NUMBER: 23-040-16

Liftgate Tail Lamps Underflush To The Body Mounted Tail Lamps

2015 - 2016 (KL) Jeep Cherokee

Fig. 2 Adding Washers To Studs

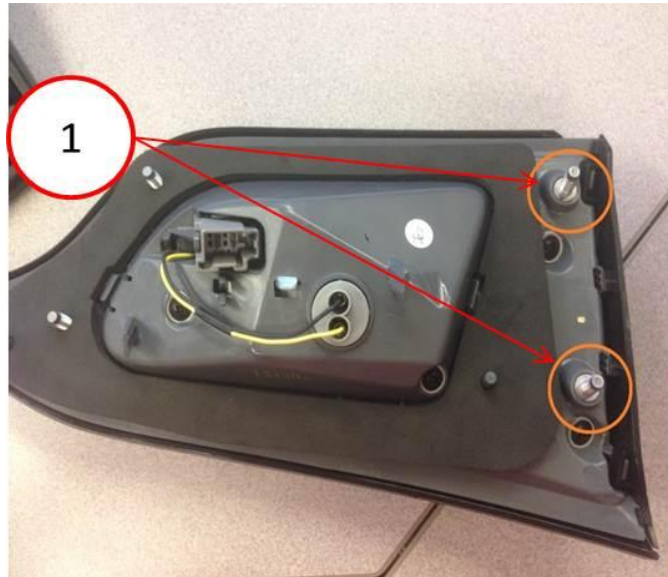
2. Add 1 washer to each outboard stud of the lift gate mounted tail lamps (Fig. 2).

1 - Washers To Be Added To Outboard Studs
